# Notice of Allowability

09/738,234

ROBERTS ET AL.

FIG. 1

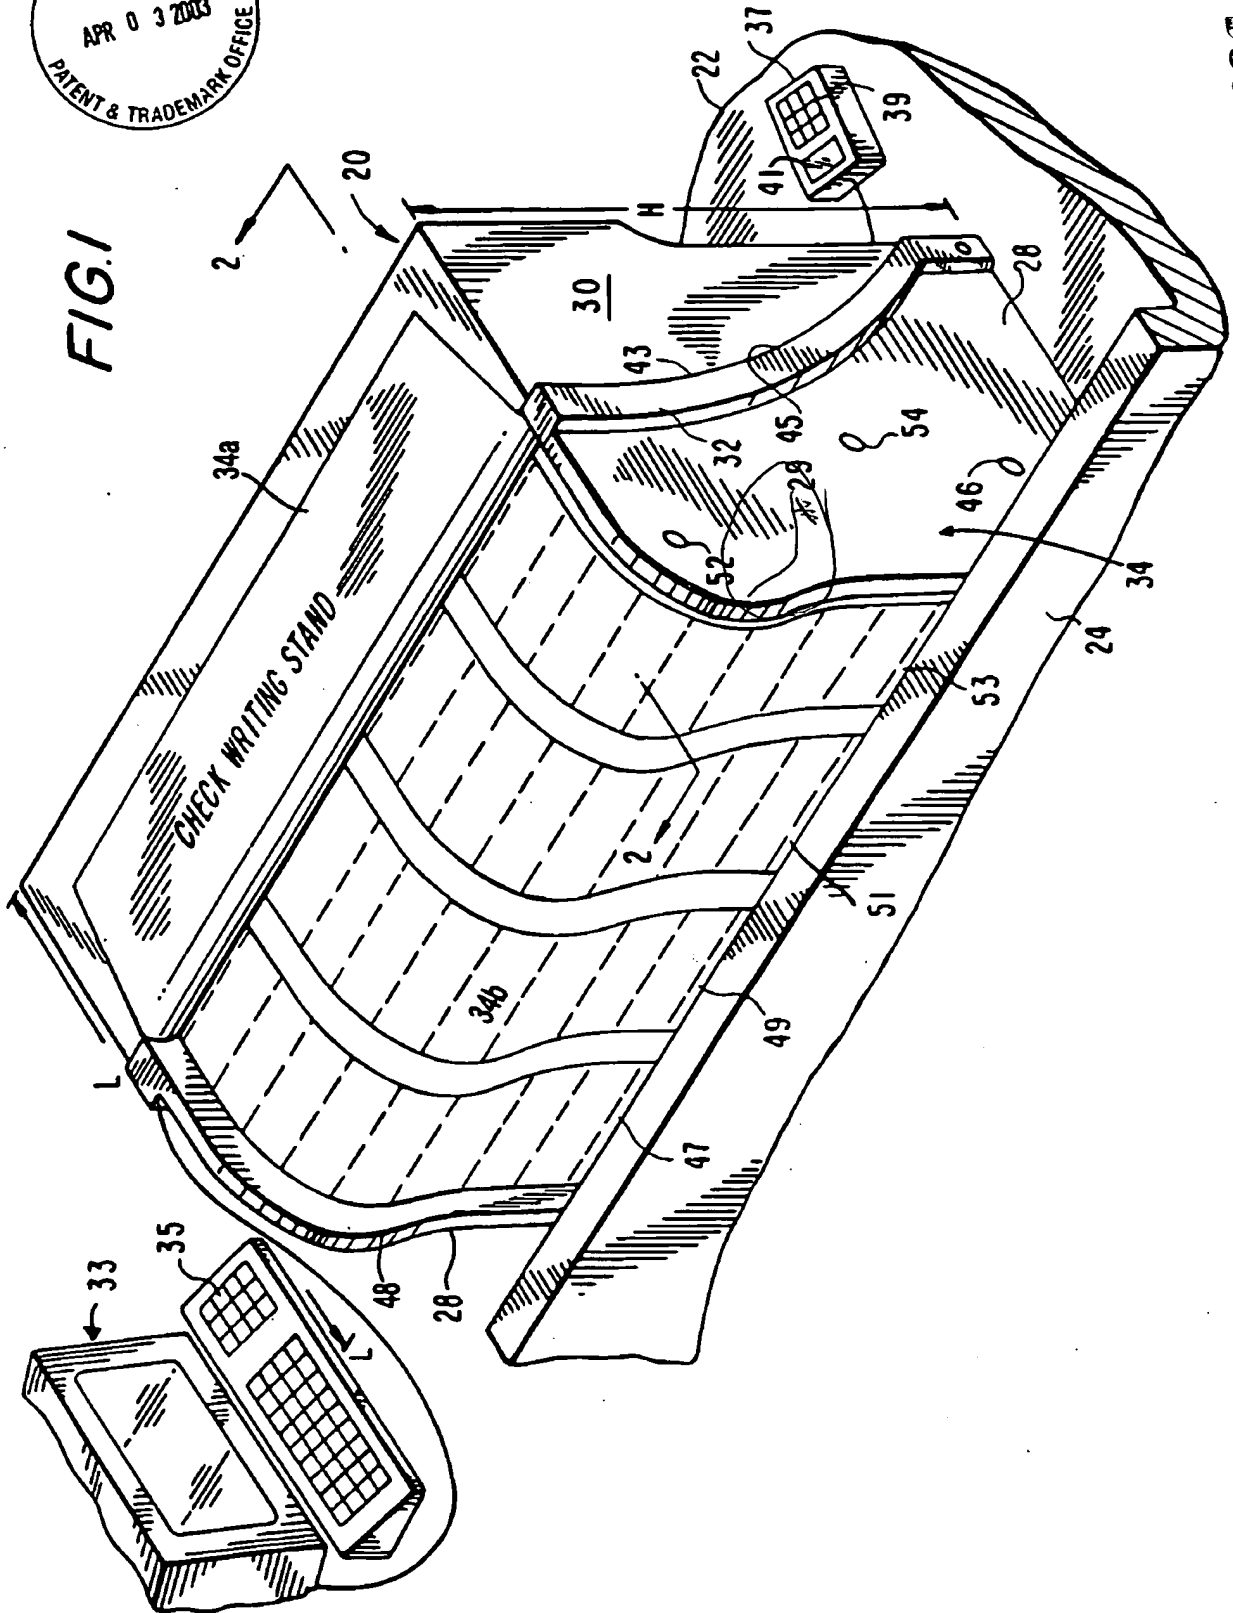
3. The following changes to the drawings have been approved by the examiner and agreed upon by applicant: In Figure 1, a lead line will be added for numeral 29 to indicate the curved portion of the side walls 28 (see paragraph 0030). The approved change is shown in a marked-up drawing included herewith. In order to avoid abandonment of the application, applicant must make these above agreed upon drawing changes.
